Post Accident AP1000 Containment Leakage An Unreviewed Safety Issue

Fairewinds Associates, Inc, April 21, 2010

A Report by Arnold Gundersen, April 21, 2010
Chief Engineer, Fairewinds Associates, Inc

Affidavit by Rudolf H. Hausler, PhD, Corro-Consulta
Re. Post Accident AP1000 Containment Leakage:
An Un-reviewed Safety Issue

- Figure 1 – AP1000 in normal operation.
- Figure 2 – AP1000 design basis accident begins.
- Figure 3 – AP1000 containment hole opens as containment fills with radioactive gases.
- Figure 4 – AP1000 chimney effect draws radioactivity directly into the environment.

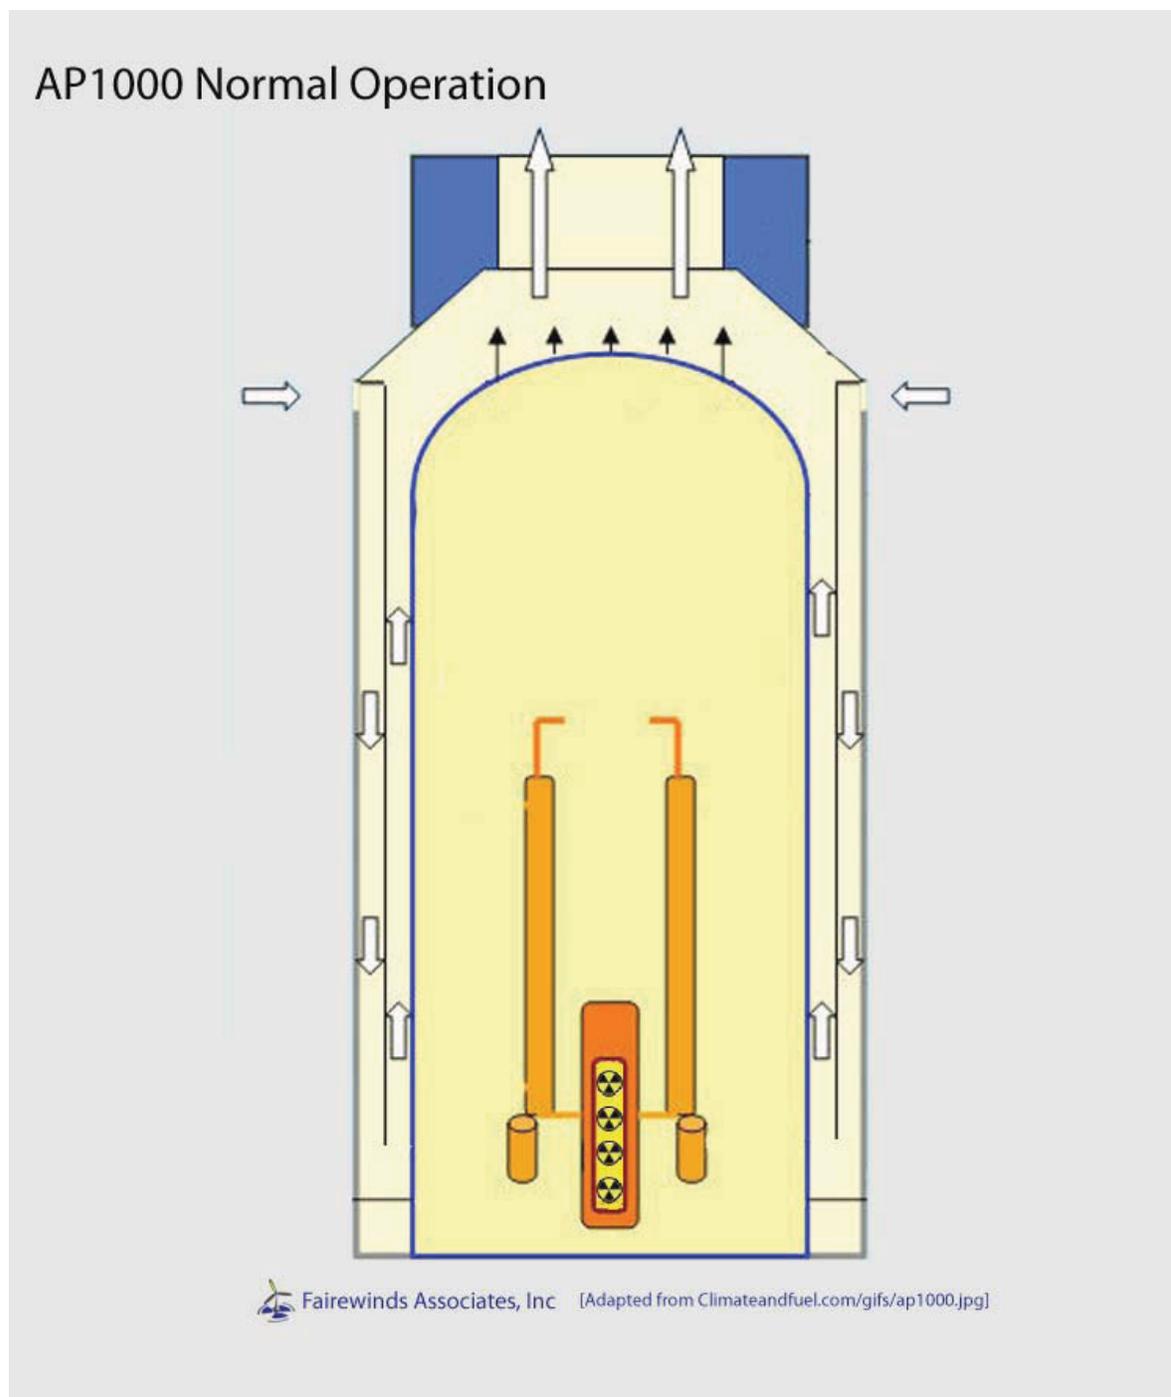
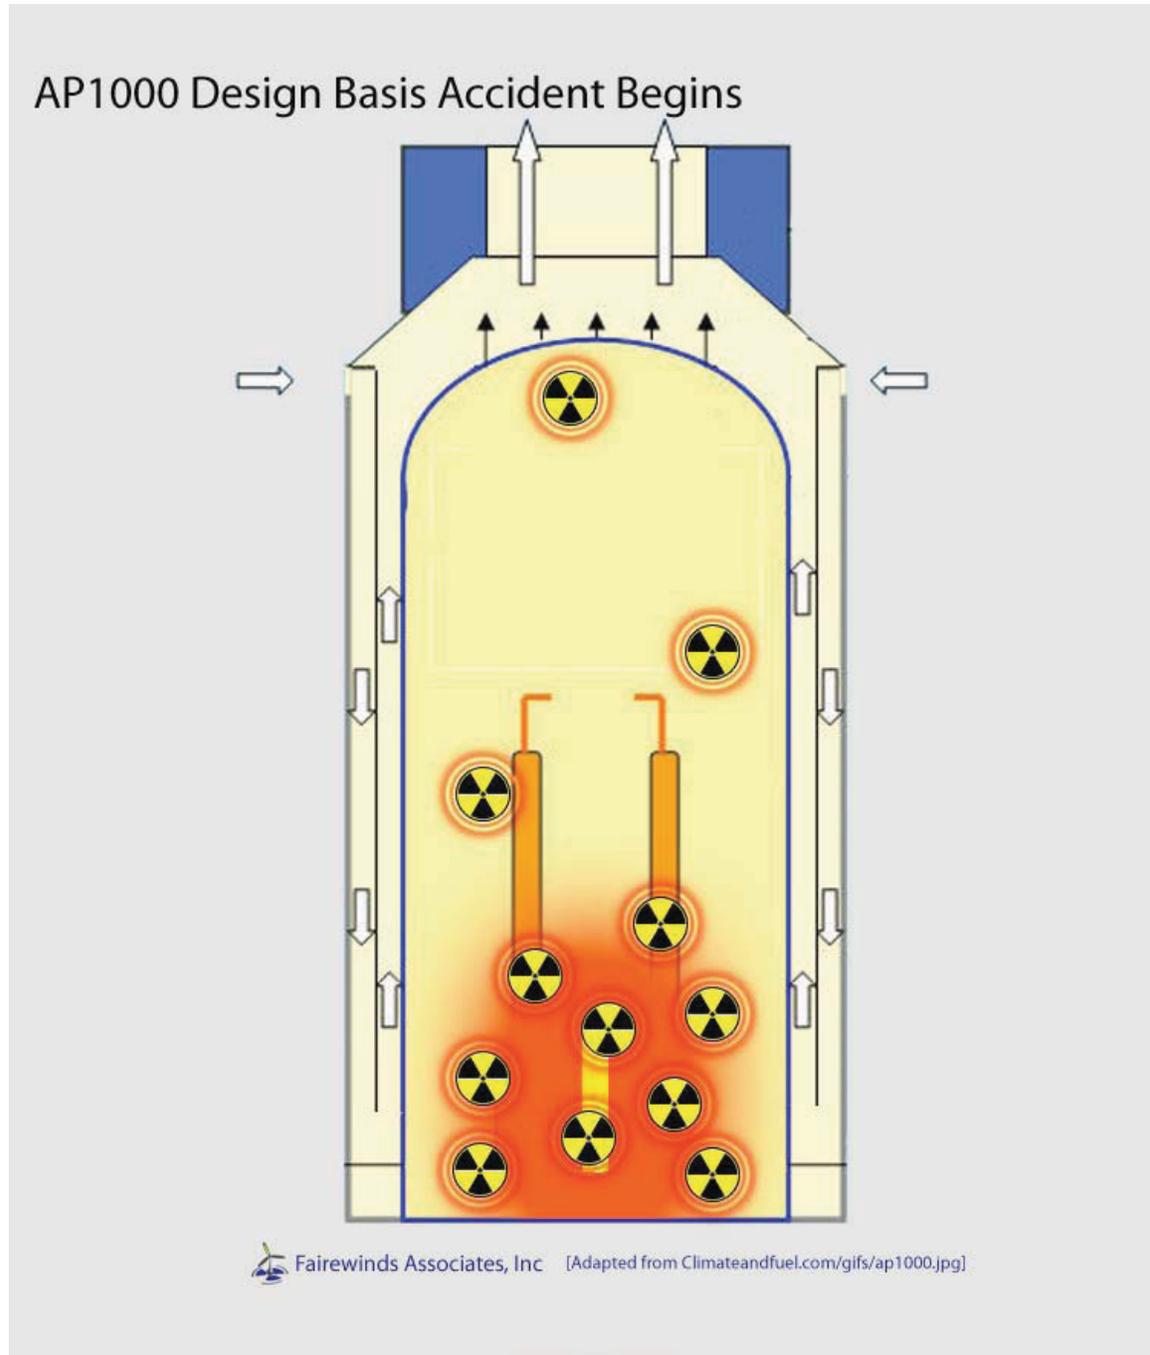
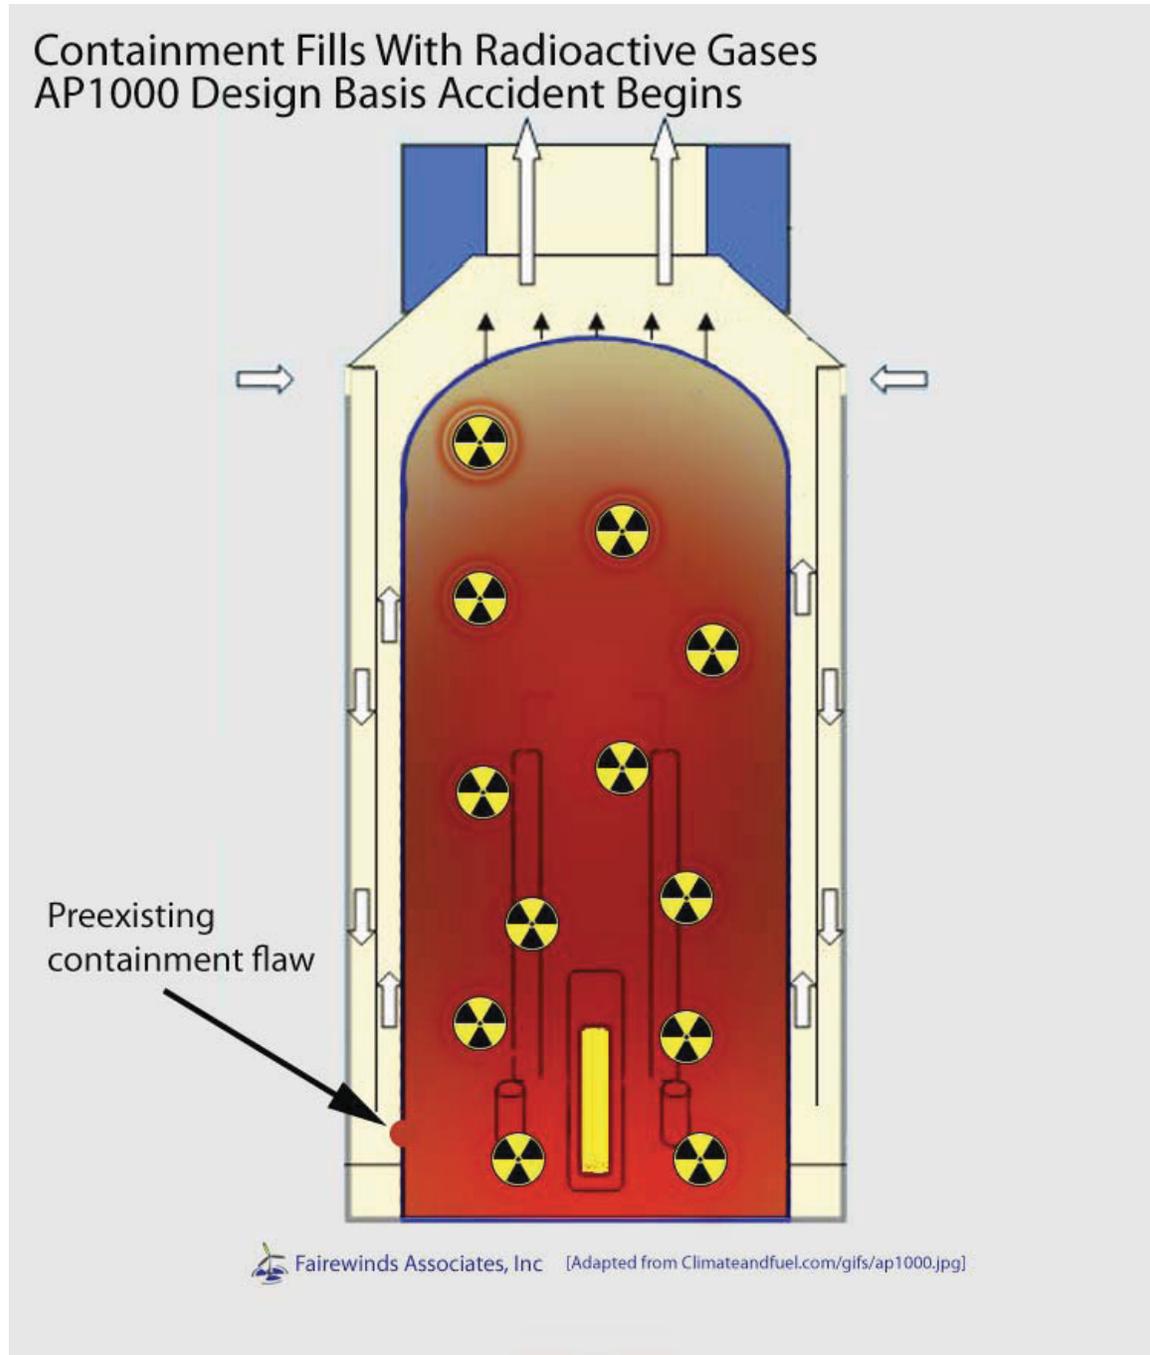
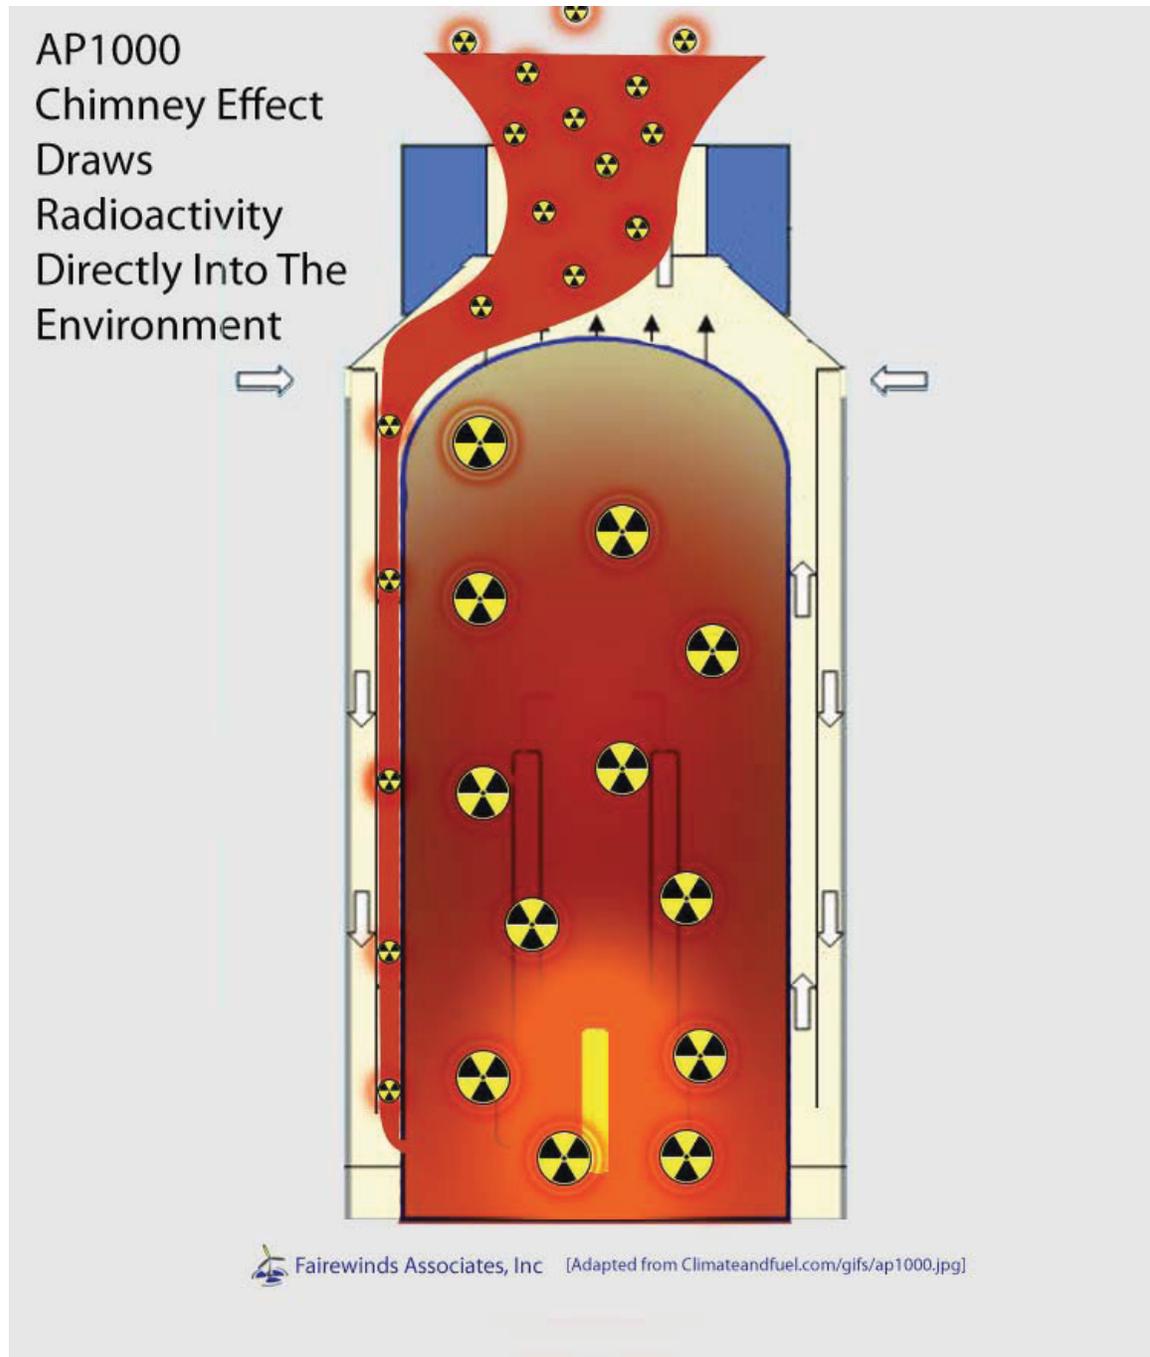
In the event of an accident at a proposed AP1000 reactor, leakage through the freestanding steel containment will pass directly into the gap between the steel and the shield building. Therefore, the proposed AP1000 containment design is inherently less safe than current reactors presently licensed and operating.

Incongruously, the purpose of *the gap between the steel and the shield building* in the design has **NOT** been created to collect and treat radiation as Dr. Petrangeli suggests would be appropriate, but rather to allow air and moisture to cool the containment itself and then to act as a chimney allowing those gases to be siphoned directly out into the environment.

Consequently, the design of the proposed AP1000 containment and its shield building might actually cause the occurrence of a larger leakage rate and a higher probability of a through-wall leakage than the currently existing containment system failures discussed above due to the active role of the AP1000 shield building in acting as a chimney which draws radioactively contaminated air into the environment.
